Report to Planning and Environment Committee

To: Chair and Members
Planning and Environment Committee
From: Scott Mathers, MPA, P.Eng.
Deputy City Manager, Planning and Economic Development
Subject: 2419361 Ontario Inc.
934 Oxford Street West
File Number: Z-9678, Ward 8
Date: January 30, 2024

Figure 3 - Conceptual Site Plan (August 2023)

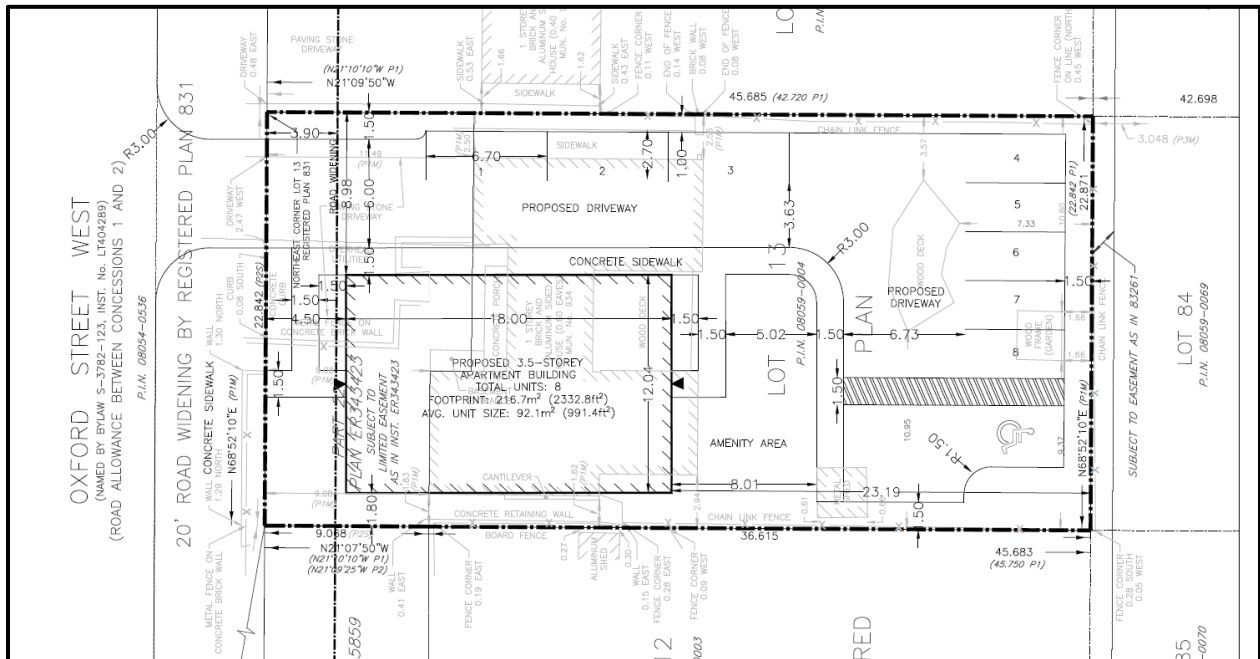
Staff identified multiple issues relating to form, such as building orientation, setbacks, and site layout. Policy 291 of The London Plan outlines that building features such as principal building entrances should face the public right-of-way, as to establish an active frontage and pedestrian access. The proposed building has the primary entrance facing east, toward the drive aisle. Renderings show that the wall facing the public right-of-way contains only small windows and does not follow the above policy.

The reduced lot frontage limits the ability to appropriately orient a building of this scale and intensity to the road (TLP 953_2). The main building entrance effectively orients the

building in such a way that the west interior side yard functions as the building's rear yard. The building entrance and layout also exacerbate setback issues. With the proposed 3.5 storey height (13 metres), a 1.8 metre setback is proposed between the building and the westerly property line. At the proposed height, a 4.5 metre interior side yard setback would normally be required: this separates the building from adjacent properties and developments, provides space for site functions and amenities, and reduces privacy concerns (TLP 953_3). In this case, the 1.8 metre setback does not allow appropriate separation, reducing needed interior side yard space to provide appropriate buffering and creating potential privacy concerns.

The site plan also does not show certain required amenities, such as waste storage (TLP 266), snow storage, and outdoor bicycle parking (TLP 280). While staff recognize the amenity space to the south of the building as a positive design element, the above omitted site features are also needed, and likely would default to the existing area used for amenity space limiting opportunity for appropriate and functional onsite amenity space for the residents. The site also requires a two-way driveway for ingress and egress and the parallel parking spaces show along the east portion of the driveway are not acceptable or safe.

The intent of a front yard depth is to ensure sufficient space between the buildings and front lot line to accommodate all site functions while still facilitating a pedestrian oriented development. The proposed 4.5 metre front a yard setback does not reflect the required road widening requirement. As per Table 6 of The London Plan, the width requirement for Oxford Street West, an urban thoroughfare, outside of the Primary Transit Area, is 22.5 metres. This leaves the proposed building as encroaching into the proposed right-of-way.

The west interior side yard setback is 1.8 metres, whereas the standard setback required would be 4.5 metres. As the building is oriented toward the east, the interior side yard setback effectively acts as a rear yard with multiple unit windows facing west, and the reduced setback significantly impacts the privacy to and from the proposed development into the existing property to the west (940 Oxford Street West). A development with the main entrance and individual unit windows oriented north-south to the street or the rear yard would be more appropriate and mitigate privacy concerns.

- 5. **Remove the parallel parking along the drive aisle** for unobstructed vehicular circulation and creating a safe pedestrian environment.
- 6. **Provide adequate landscape buffer between the property line and the drive aisle/parking** to avoid any negative impacts on the adjacent properties. TLP 278

Figure 5 – Lotting pattern for 934 Oxford Street West and adjacent lots

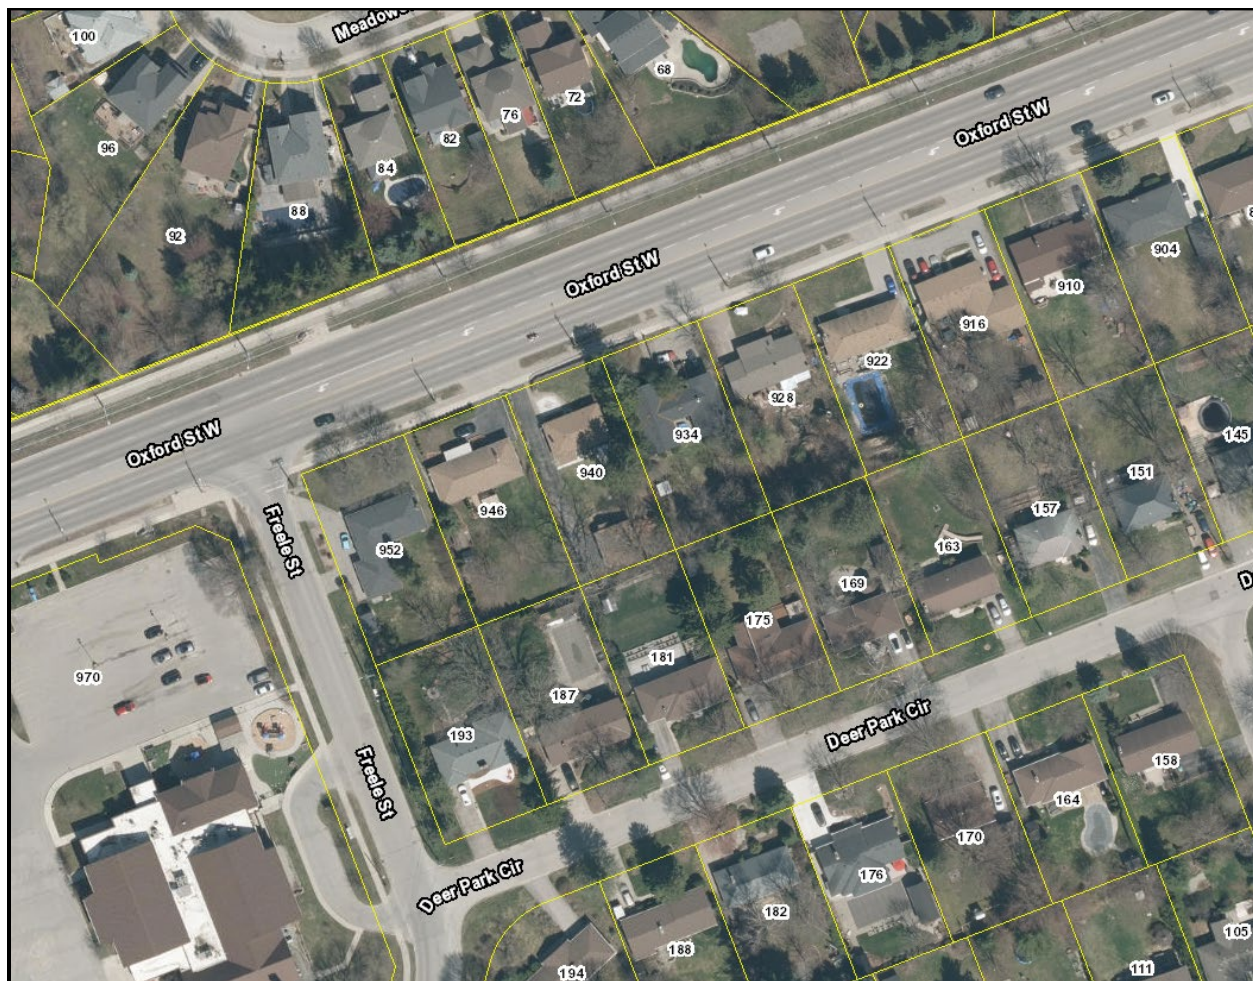
The proposed development and its issues related to form and intensity cause potential larger-scale issues relating to future development within this section of Oxford Street. Given the consistent lot fabric on the south side of Oxford Street West, (see figure 5) Staff are concerned that similar, development could occur creating long term planning impacts to the area. Staff are supportive of intensification along this corridor, including within apartment forms, however appropriate land consolidation must occur to the achieve lot frontages and areas that can appropriately accommodate the proposed intensity and required onsite functions.

Key direction 8 of The London Plan requires thinking long-term when making planning decisions to consider the implications of site-specific planning decision within the context of the 'big picture' (62_3). If approved as proposed, the proposed development would set a precedent for more properties along Oxford Street West to develop in a similar manner, leading to a large number of driveways along the road and not developing in a manner in keeping with Access Management Guidelines. While the proposed intensity can be considered appropriate within the Neighborhood Place Type along Urban Thoroughfares, developments occurring as a result of consolidation with fewer individual driveways would be preferred in similar cases.
